RE: CRT Docket No. 2004-DRS01; Comment on ANPRM Concerning Implementation of Revised ADA and ABA Guidelines Dear Assistant Attorney General Acosta:

Question 9 Barrier Removal – General affects of revised ADA Standards

Reference Van Accessible parking Figure 502.2 of the new ADAAG Section 502.

Figure 502.2
Vehicle Parking Spaces

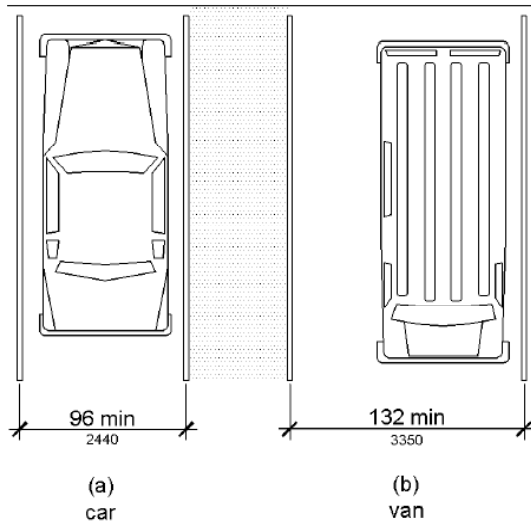
Since backing into a van accessible parking space is quite difficult for some people I think it is very bad form to show a figure illustrating the more difficult to use configuration. It is true that the model codes and new ADA/ABA AG do permit back-in van accessible parking configurations.

I prefer the corresponding figure 502.2 from ICC/ANSI A117.1-2003 which has the van in a pull-in configuration. Please consider using the ANSI version in the new document. Or consider swapping the new AG figures 502.2 and 502.3 around so the pull-in version is first in Section 502.

Another issue is the change of first choice specification for van accessible parking to have a 132" wide parking space with a 60" access isle from the old (and still permitted) standard of 96" wide parking space with a 96" access isle. I think this is a major mistake

leading to even lower compliance and understanding by the layman, drivers, and business owners. They won't even notice the distinction of the wider parking spot and the access aisles will look the same. The old standard had the clearly obvious difference in access aisle widths which are quite noticeable to the layman. As a van driver in the drivers seat it will difficult to notice the 36" difference in parking spot width to know if it can provide the 96" required clear space for the wheel chair to exit the side lift platform.

The narrower access aisle may prevent a van backing into the right hand spot if a car (probably not a van) parks in the left hand spot closer than 36" to the center access aisle.
